# **SECRETARY OF THE INTERIOR (SOI) COMPATIBILITY ASSESSMENT FOR BUILDING #3 “THE OLD SCHOOL HOUSE” RECONSTRUCTION PROJECT, PAUL ECKE CENTRAL ELEMENTARY SCHOOL, ENCINITAS, SAN DIEGO COUNTY, CALIFORNIA**

**Type of Study:** SOI Compatibility Assessment

**Resource:** Building #3, “Old School House”

The Project's schematic design dated October 30, 2025 (50% complete) was prepared by DLRGroup and a copy provided to Cogstone by PlaceWorks (Appendix B). These plans identify Building #3 (Building 300, Old School House) as Building 500. For consistency in this study the building will continue to be referred to as Building #3. The October 2025 plans depict alterations to the interior and exterior of Building #3.

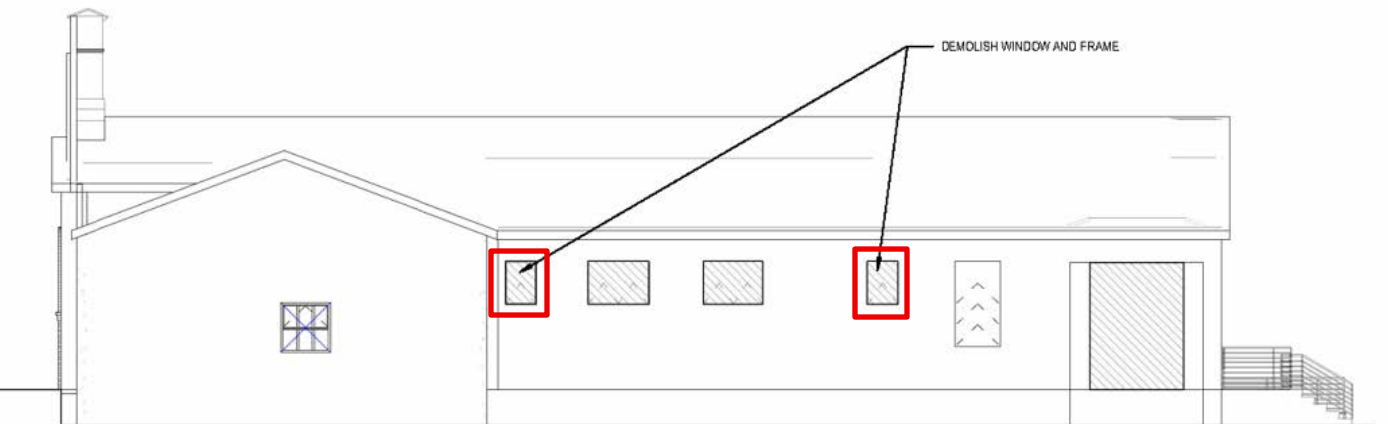
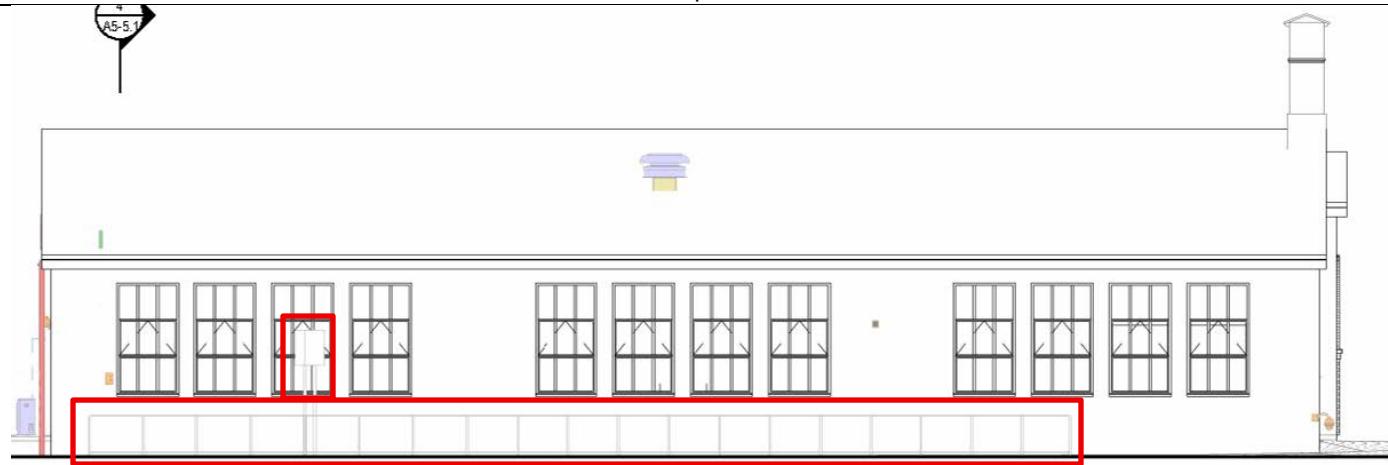
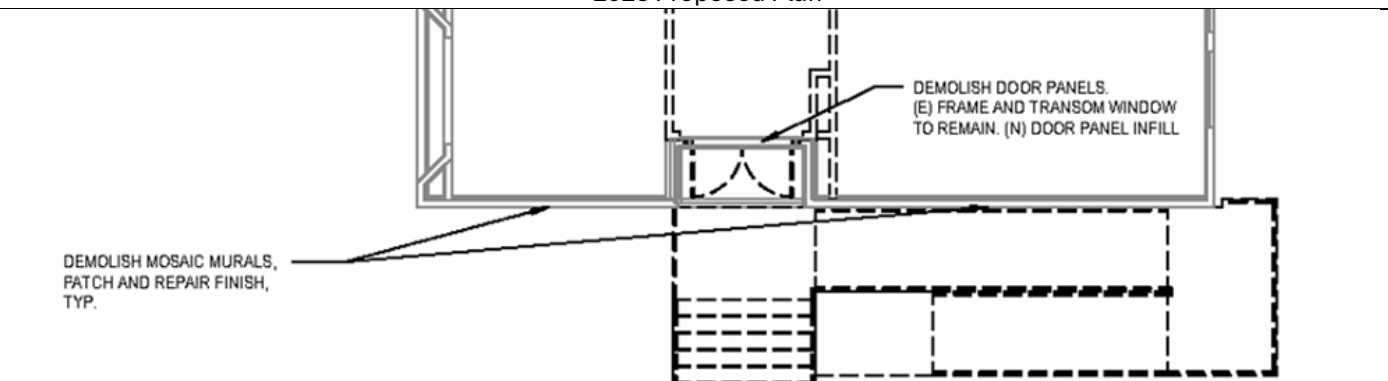
| NO. | LOCATION                                                     | FEATURE                                      | DLRGroup 2025 DESIGN PLAN                                                                                     | COMPATIBILITY WITH SOI STANDARDS                                                                                                                                                                                                                                                                                                                                                                                                                                                                                                                                                                                                                                                                                                                                                                                                                                                                                                                                                                                                                                                                                                                                                                                                                                                                                                                                                                                                                                                             | IMAGE(S)                                                                                                                                                                                                                                                                                                    |
|-----|--------------------------------------------------------------|----------------------------------------------|---------------------------------------------------------------------------------------------------------------|----------------------------------------------------------------------------------------------------------------------------------------------------------------------------------------------------------------------------------------------------------------------------------------------------------------------------------------------------------------------------------------------------------------------------------------------------------------------------------------------------------------------------------------------------------------------------------------------------------------------------------------------------------------------------------------------------------------------------------------------------------------------------------------------------------------------------------------------------------------------------------------------------------------------------------------------------------------------------------------------------------------------------------------------------------------------------------------------------------------------------------------------------------------------------------------------------------------------------------------------------------------------------------------------------------------------------------------------------------------------------------------------------------------------------------------------------------------------------------------------|-------------------------------------------------------------------------------------------------------------------------------------------------------------------------------------------------------------------------------------------------------------------------------------------------------------|
| 5.  | Southern end of west elevation                               | Canted bay window and decorative brick apron | Removal of window and brick apron to be replaced with a double-door and transom window.                       | <p><b>No.</b> The canted bay window and brick apron is a distinct character defining feature of this building. Removal of this feature would have a significant adverse impact on the building’s historic design, workmanship, and feeling.</p> <p>This alteration is not compatible with the SOI standards for Rehabilitation: #2. <i>The historic character of a property will be retained and preserved. The removal of distinctive materials or alteration of features, spaces and spatial relationships that characterize a property will be avoided.</i>”</p>                                                                                                                                                                                                                                                                                                                                                                                                                                                                                                                                                                                                                                                                                                                                                                                                                                                                                                                          |  <p>Proposed alteration</p>                                                                                                                                                                                              |
| 6.  | Western end of (recessed) south elevation and west elevation | Addition of secondary doors                  | Addition of double doors at western end of (recessed) south elevation and two single doors at west elevation. | <p><b>Acceptable but with conditions.</b> A review of a 1932 photograph (Figure #5) of the schoolhouse depicts a set of narrow double doors (wood frame with glass panes) and transom window near the midpoint of the west elevation (no longer extant). The photograph also depicts a shallow pitched access ramp (no longer extant) along the western end of the south elevation which indicates the presence of a door. A portion of the enclosure (topped with red tile roofed overhang) leading to the basement (no longer extant) is also visible.</p> <p>The 1998 reconstruction plans (Appendix C; Leidenfrost/Horowitz &amp; Associates 1998) for “Building 3” depicts double doors at the western end of the south elevation which were removed and filled in as a result of that project. Therefore, the 2025 proposed plan to install double doors in that exact location would restore a lost feature of the building’s original plan. This would be considered a positive to the building’s integrity of design.</p> <p>The 1998 reconstruction plans removed and filled in the openings for the original narrow pedestrian door and basement door (with access steps). Access to the basement was filled in with dirt and gravel to align with adjacent landscaping. The proposed 2025 Project plans will install two single pedestrian doors near the location of the building’s original (though no longer extant) doors. This installment will not restore the missing</p> |  <p>2025 Proposed Project</p> <p>Basement access</p> <p>1998 Building 3 reconstruction plan. Doors were removed and openings filled in as part of Project. Basement access was also filled in with dirt and gravel.</p> |
|     |                                |                                                                                                                                                                                                                         |                           | architectural features but will reflect an architectural precedent seen in the original design. <b>However, the installation of these doors must not result in the removal of the existing window openings on this segment of elevation as those openings are most likely part of the building’s original design (according to review of historic photographs and the 1998 reconstruction plans) and are considered a character defining feature.</b>                                                                                                                                                                                                                                                                                                                                                                                                                                                                                                                                                                                                                                                                                            |  <p>Proposed doors</p>                                                                                                                                                       |

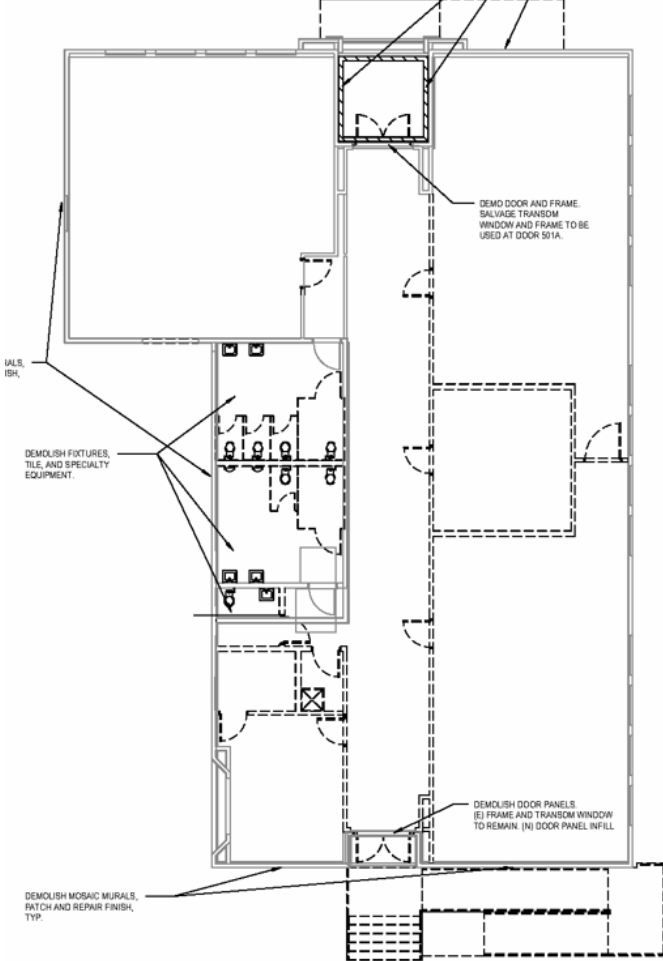
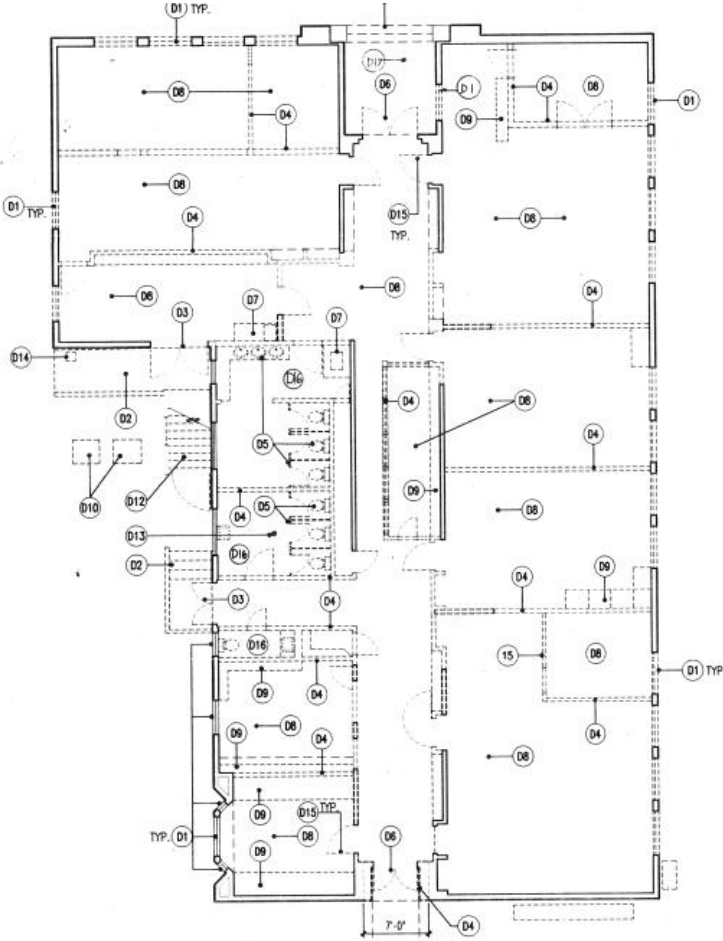
| NO. | LOCATION                       | FEATURE                                                                                                                                                                                                                 | DLRGroup 2025 DESIGN PLAN | COMPATIBILITY WITH SOI STANDARDS                                                                                                                                                                                                                                                                                                                                                                                                                                                                                                                                                                                                                                                                                                                                                                                                                                                                                                                                                                                                                                                                                                                 | IMAGE(S)                                                                                                                                                                                                                                                        |
|-----|--------------------------------|-------------------------------------------------------------------------------------------------------------------------------------------------------------------------------------------------------------------------|---------------------------|--------------------------------------------------------------------------------------------------------------------------------------------------------------------------------------------------------------------------------------------------------------------------------------------------------------------------------------------------------------------------------------------------------------------------------------------------------------------------------------------------------------------------------------------------------------------------------------------------------------------------------------------------------------------------------------------------------------------------------------------------------------------------------------------------------------------------------------------------------------------------------------------------------------------------------------------------------------------------------------------------------------------------------------------------------------------------------------------------------------------------------------------------|-----------------------------------------------------------------------------------------------------------------------------------------------------------------------------------------------------------------------------------------------------------------|
| 7.  | Northern end of west elevation | Exterior wall <ul style="list-style-type: none"><li>• Removal of mosaic murals, patch and repair finish.</li><li>• Installation of HVAC units/mechanical equipment at the lower portion of the exterior wall.</li></ul> |                           | <p><b>Yes.</b> The mosaic is not a contributing character defining feature of this building. Removal of the mosaic mural would have no adverse impact on the significance of the building. This action would also remove a non-historic visual element from this segment of wall which was originally unadorned.</p> <p><b>Not recommended.</b> A review of a 1932 photograph of the building shows this segment of the west elevation originally consisted of a round gable roof vent and two small rectangular ground level vents. While these three features remain extant, a small window has been added (date unknown) as well as the existing mosaic (added ca. 2009). The removal of the mosaic would restore a portion of the wall’s original “bare” design; however, the addition of the HVAC units/mechanical equipment would negatively impact the visual character of this portion of the building’s design as seen from the public right of way. An alternative recommendation would be to mount said equipment out of the public’s field of view such as in the existing carve-out at the southern facing segment of the roof.</p> |  <p>Proposed alteration</p>  <p>1932 photograph of northern end of west elevation.</p> |

| NO. | LOCATION                  | FEATURE                         | DLRGroup 2025 DESIGN PLAN                                                                                               | COMPATIBILITY WITH SOI STANDARDS                                                                                                                                                                                                                                                                                                                                                                                                                                                                                                                                                                                                                                                                                                | IMAGE(S)                                                                                                       |
|-----|---------------------------|---------------------------------|-------------------------------------------------------------------------------------------------------------------------|---------------------------------------------------------------------------------------------------------------------------------------------------------------------------------------------------------------------------------------------------------------------------------------------------------------------------------------------------------------------------------------------------------------------------------------------------------------------------------------------------------------------------------------------------------------------------------------------------------------------------------------------------------------------------------------------------------------------------------|----------------------------------------------------------------------------------------------------------------|
| 8.  | West elevation            | Small windows at west elevation | Removal of window and infill of window openings                                                                         | <b>No.</b> According to a review of the 1932 historic photograph and 1998 reconstruction plans of this elevation, these window openings are most likely part of the building's original fenestration design and their removal would have an adverse impact of the building's integrity of design. (Note: the window materials are replacements and not original to the building).                                                                                                                                                                                                                                                                                                                                               |  <p>2025 Proposed Plan</p>  |
| 9.  | East elevation            | Mechanical equipment            | Addition of mechanical equipment along ground level of elevation and raised electrical box at southern end of elevation | <b>Acceptable.</b> Equipment will be primarily ground level at the exterior of the elevation and largely obscured from public view. It is recommended that vegetation be maintained in this area to help obscure view of the equipment.                                                                                                                                                                                                                                                                                                                                                                                                                                                                                         |  <p>2025 Proposed Plan</p> |

BLDG 500 - WEST ELEVATION DEMO

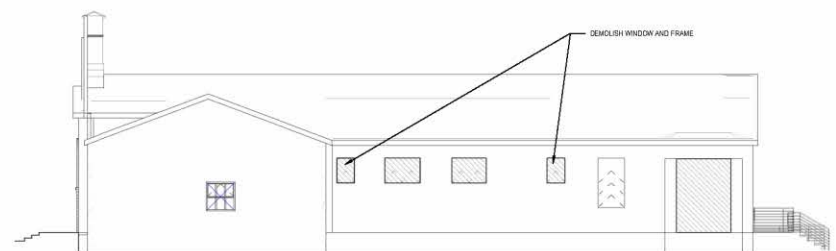
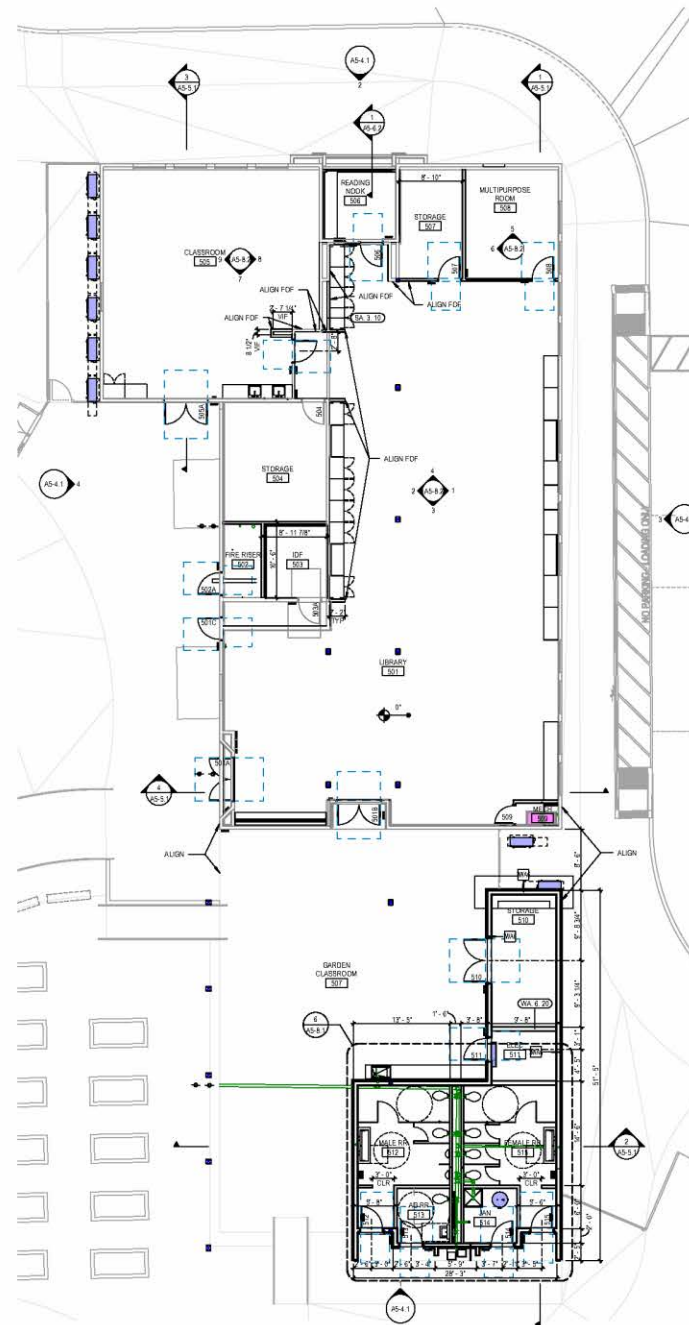
- o *#4, Proposed work: Demolish door and frame. Salvage transom window and frame to be used at door 201A. Selectively demolish finish and substrate to studs and preserve brick veneer. Demolish stucco and substrate for entire entry. Replace stucco finish with gypsum board.* The primary entrance configuration of the building is a major character defining feature and a distinct feature of the building’s design. Removal and/or permanent blockage of this entrance would represent a major adverse impact to the building’s historic design, workmanship, and feeling. In addition, as the building’s

- o *#5, Proposed work: Removal of canted bay window and brick apron to be replaced with a double-door and transom window.* The canted bay window and brick apron is a distinct character defining feature of this building. Removal of this feature would have a significant adverse impact on the building's historic design, workmanship, and feeling.

- o *#7, Proposed work: Installation of HVAC units/mechanical equipment at the lower portion of the exterior wall.* The addition of the HVAC units/mechanical equipment would negatively impact the visual character of this portion of the building's design, as seen from the public right of way.

- The most extensive alteration to the building is the interior demolition of spaces (removal of walls dividing Classroom 22, Room 25, Classroom 21, Classroom 24, and Custodian closet). The intent is to convert the new open space for use as a library, which is congruous with the schoolhouse's historic use as an educational building. The original design of the interior of the building is not known, however, substantial alterations were previously undertaken in the 1998 Reconstruction Project. The interior alterations, with the exception of the installation of the reading nook, will not impact the building's eligibility for listing as a historic resource.

- #4: The primary entrance of this building is an important character defining feature that is visible to the public and should **not** be removed or altered in such a way that its original intended use is erased.
- #5: The canted bay window and decorative brick apron should be left extant as it is a unique character defining feature.
- #7: An alternative recommendation would be to mount said equipment out of the public's field of view such as in the existing carve-out at the southern facing segment of the roof.
